ADDENDUM

Use of Recycled Water and Associated Facilities

Sacramento Power Authority's Campbell Cogeneration Project

(93-AFC-3C)

Figure 2R. Pipeline and Laydown Area
SPA Campbell Cogeneration Project

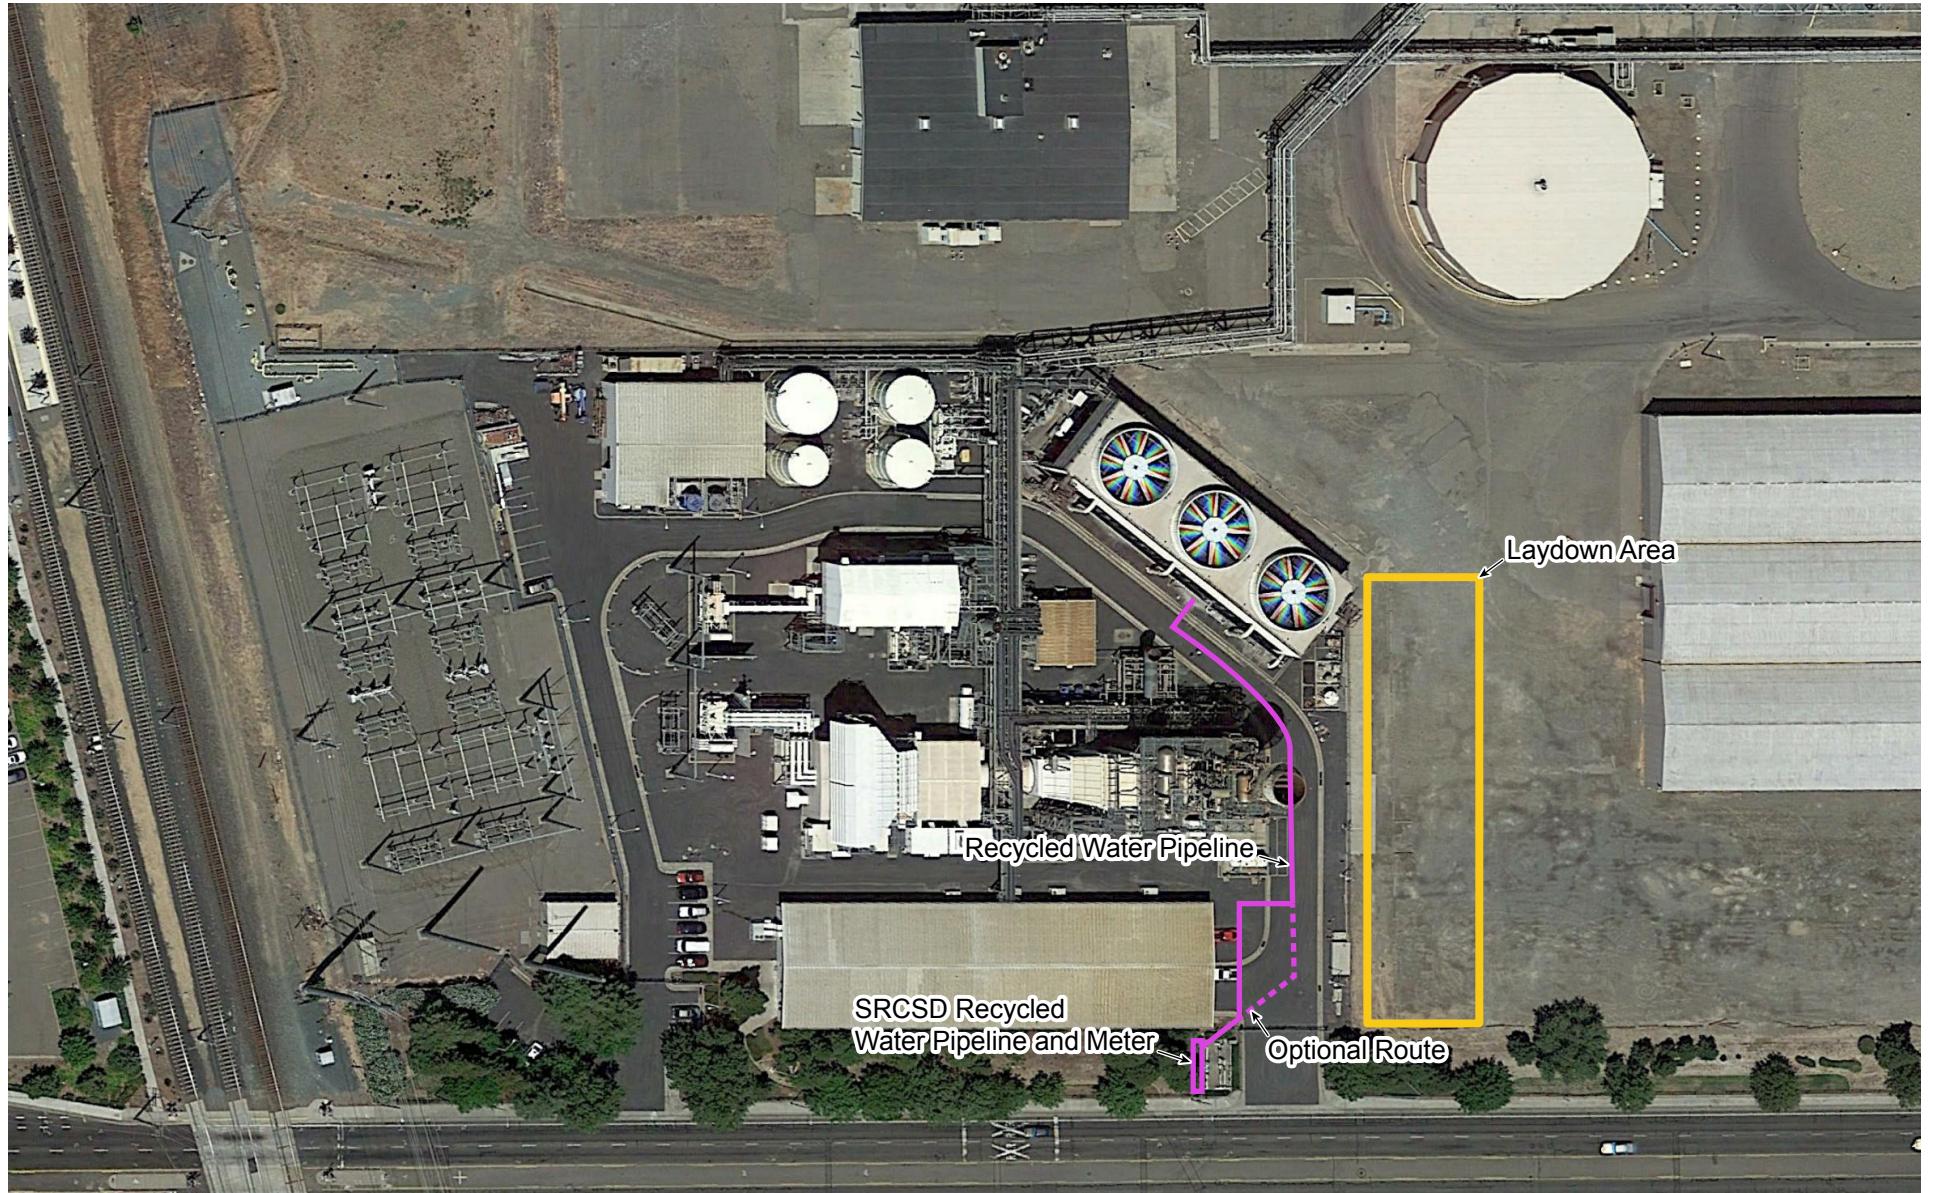
The PTA stated that two possible locations were being considered for the recycled water line—one on each side of the plant's 47th Avenue east driveway. As a result of further engineering design, it has been determined that the recycled water line connection point will be located on the west side of the driveway, to the west of the existing potable water supply lines. In addition, due to the number of existing pipelines in this part of the plant, two possible routes have been identified. These routes are only approximate and may need to be modified further during construction to avoid existing pipelines. In addition, because of the congestion, the new recycled water line may need to be installed as much as 10 feet deep. Figure 2 of the PTA has been revised, as Figure 2R, to reflect the location of the recycled water line connection, valves, and meter, as well as the possible pipeline routes.

Since the PTA addressed two possible locations of the water line and one of those locations—to the west of the existing potable water supply lines—has been chosen (see Figure 2R), no additional environmental analysis is needed. Because of the number of existing pipelines in the southern part of the plant, the depth of the recycled water pipeline needs to be increased from 6 feet to 10 feet below ground surface. Potential impacts from the increased depth are addressed in Section 3.3, below.
